City of Detroit
Inter-Departmental Communication

RE: REVISED Petition No. 1385
Requested Encroachment into Russell at 2727 Russell (with Outdoor Seating)

**REQUEST ENCROACHMENT
 INTO RUSSELL
 AT 2727 - 2739 RUSSELL
 (With Outdoor Seating and Planters)**

PROVISIONS FOR ENCROACHMENT For Petition 1385

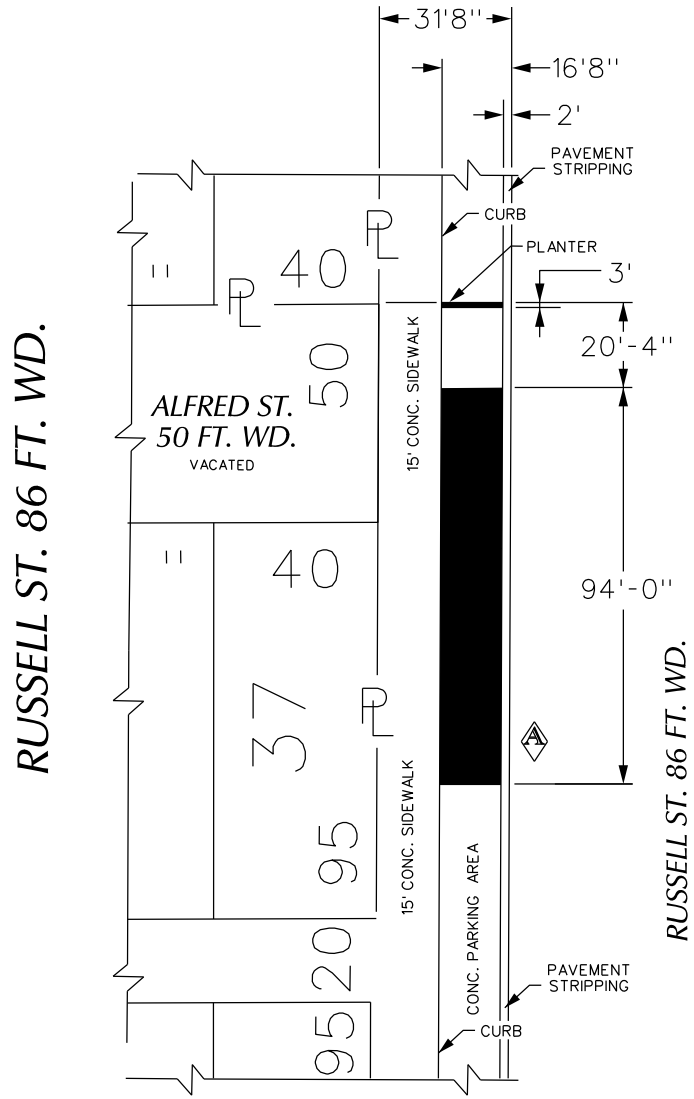
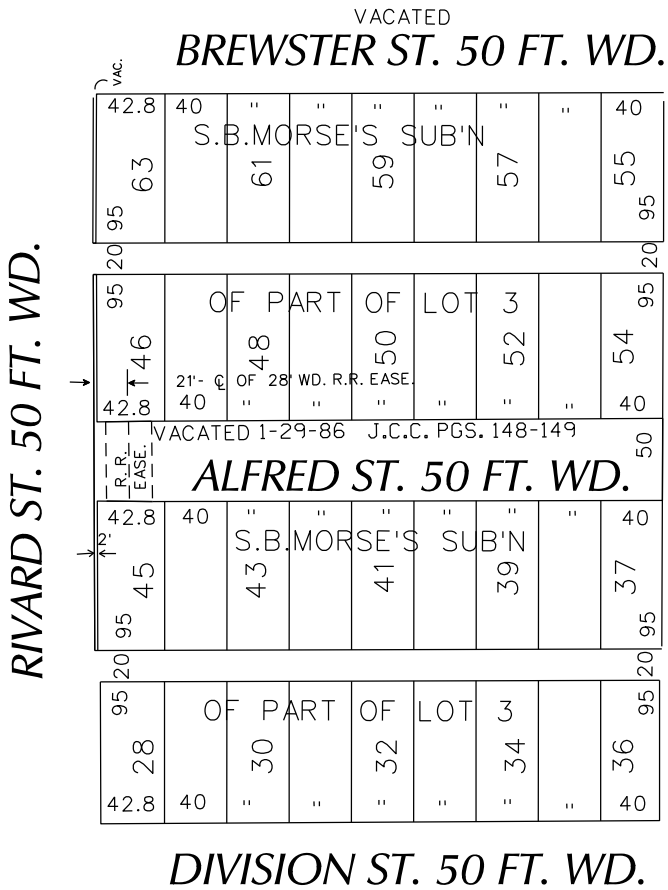
- DWSD has no objection to the requested encroachment provided that the attached Provisions for Encroachment are strictly followed.

B					
A	INCREASE ENCROACHMENT LENGTH TO 94'-0"	WLW	KSM	KSM	4/18/17
DESCRIPTION		DRWN	CHKD	APPD	DATE
REVISIONS					
DRAWN BY	WLW	CHECKED			
DATE	03-14-17	APPROVED

1. By approval of this petition the (DWSD) does not waive any of its rights to its facilities located in the right of way, and at all time, DWSD, its agents or employees, shall have the right to enter upon the right of way to maintain, repair, alter, service, inspect, or install its facilities. All costs incident to the damaging, dismantling, demolishing, removal and replacement of structures or other improvements herein permitted and incurred in gaining access to DWSD's facilities for maintenance, repairing, alteration, servicing or inspection caused by the encroachment shall be borne by the petitioner. All costs associated with gaining access to DWSD's facilities, which could normally be expected had the petitioner not encroached into the right of way shall be borne by DWSD.

2. All construction performed under this petition shall not be commenced until after five (5) days written notice to DWSD. Seventy-two (72) hours notice shall also be provided in accordance with P.A. 53 1974, as amended, utilizing the MISS DIG one call system.

3. Construction under this petition is subject to inspection and approval by DWSD forces. The cost of such inspection shall, at the discretion of DWSD, be borne by the petitioner.

4. If DWSD facilities located within the right of way shall break or be damaged as the result of any action on the part of the petitioner, then in such event the petitioner agrees to be liable for all costs incident to the repair, replacement or relocation of such broken or damaged DWSD facilities.
